SECTION 00911 - ADDENDUM 2

- A. Project Name: South Main Corridor Improvement Project (Phase II)
- B. Engineer: SK Design Group, Inc.
- C. Engineer's Project Number: 16-108.
- D. Date of Addendum: August 3, 2023

South Main Corridor Improvement Project (Phase II)

CONTROLLER SCHEDULES

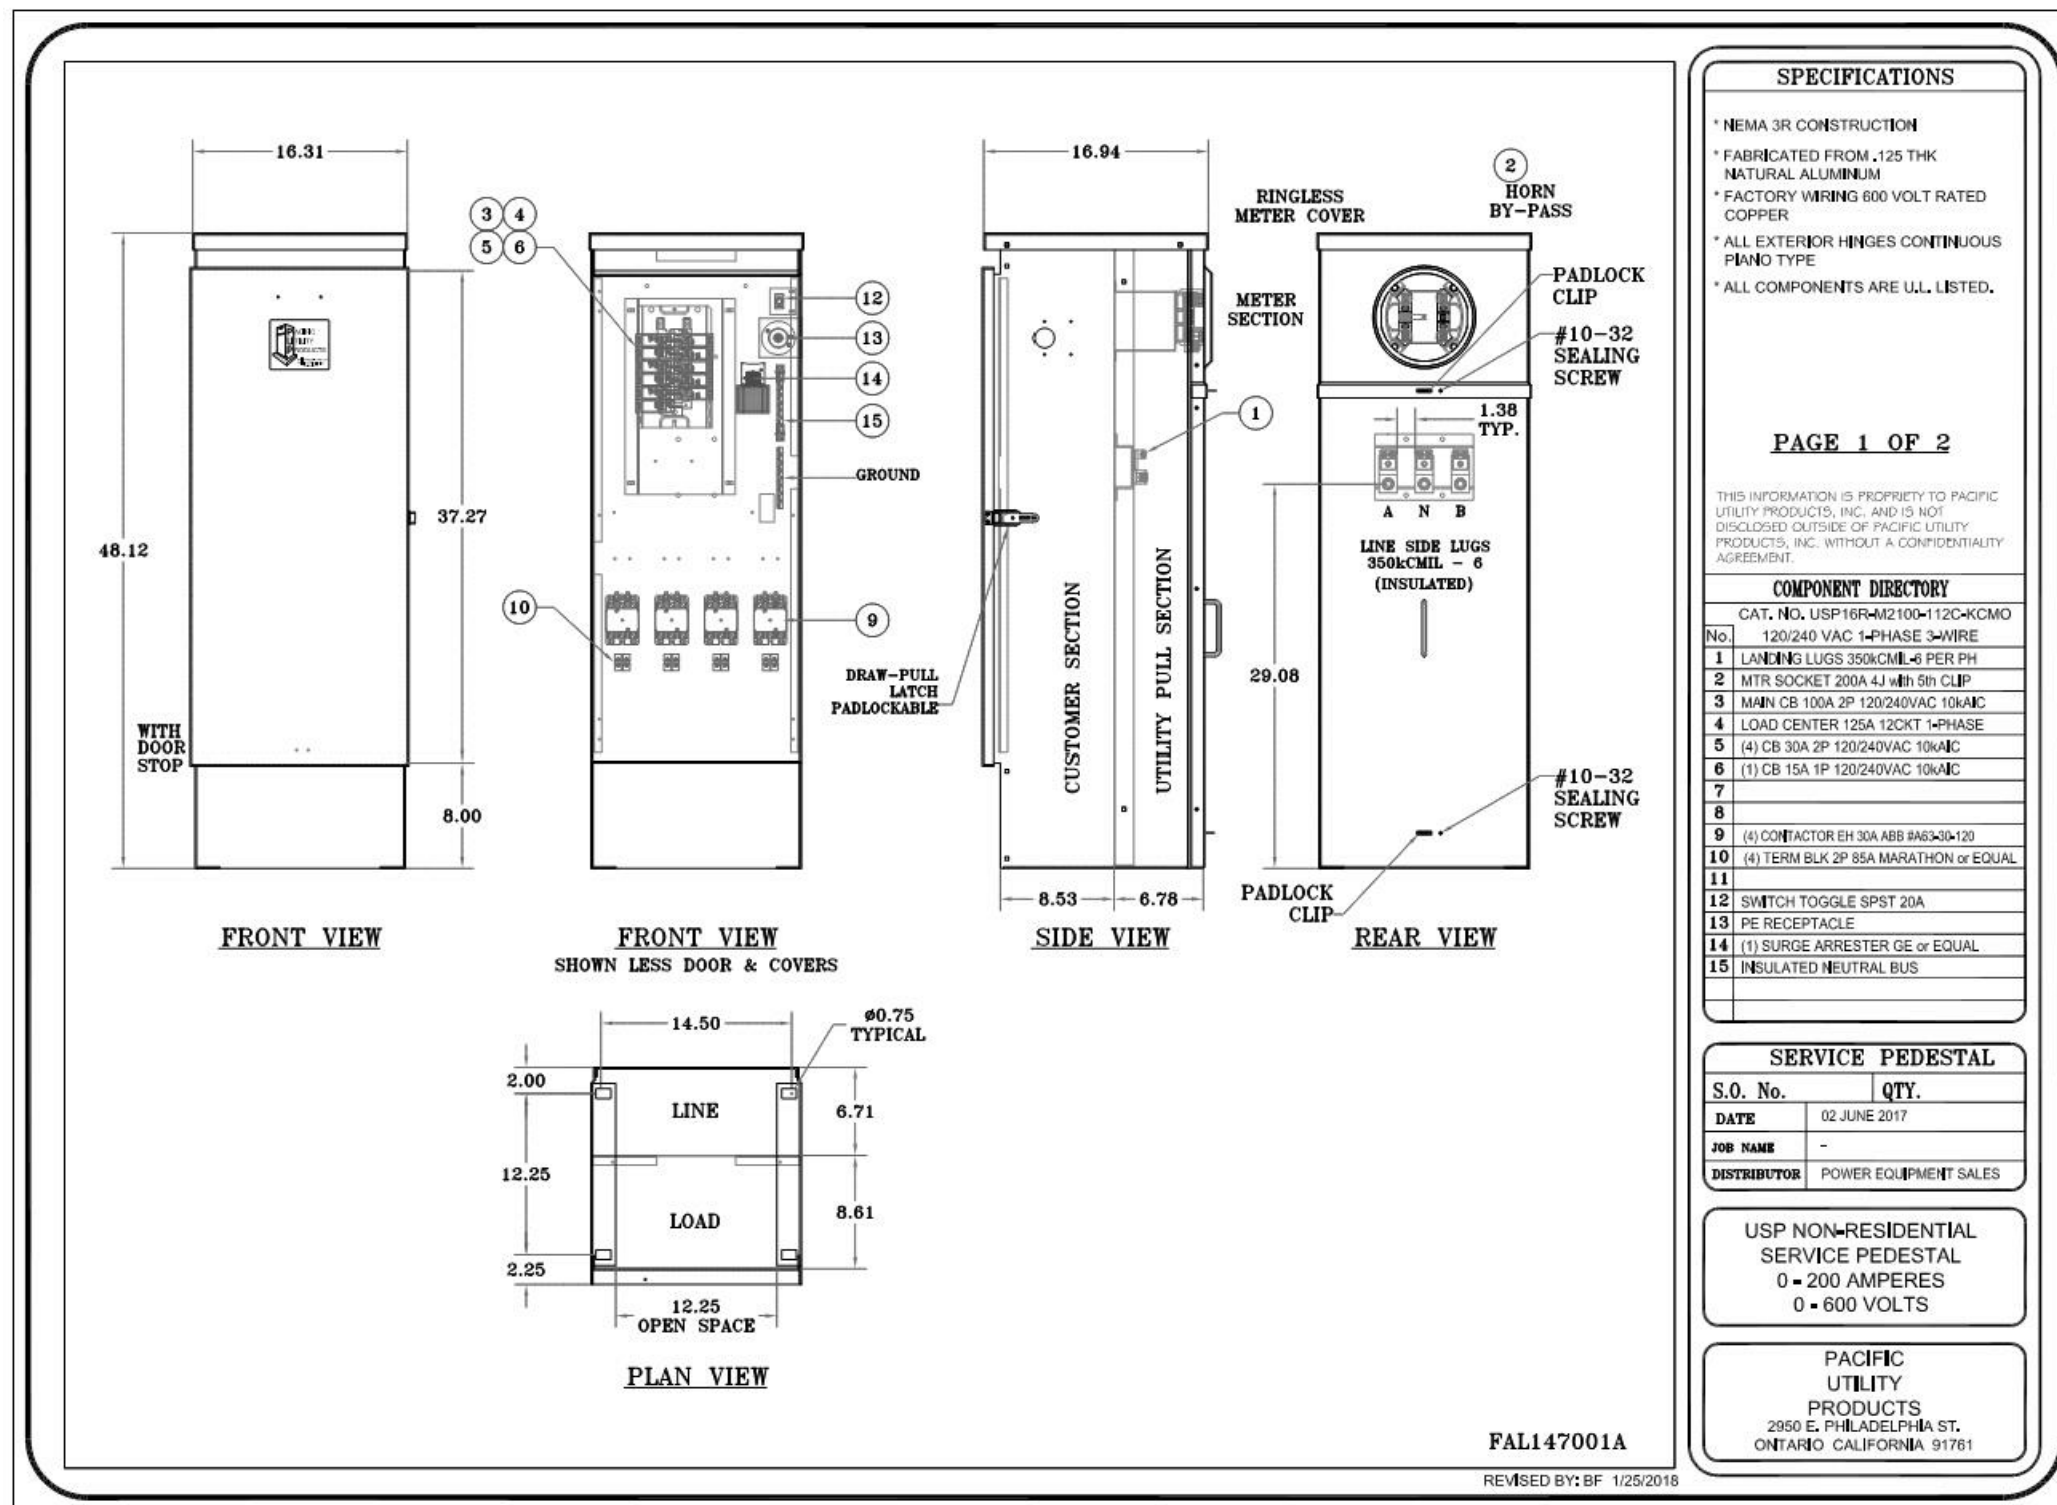
- G. Question: On sheet SE303 under the controller schedule it shows on controller F that circuit 3 is used for signage. On the drawings there is no indication of signage lighting on controller F. Please clarify if signage lighting is to be installed.

Response: Controller F schedule is revised to include "Streetlighting/Signage." See attached revised sheet SE303. Refer to Note 6 on SE204 for location where signage is located.
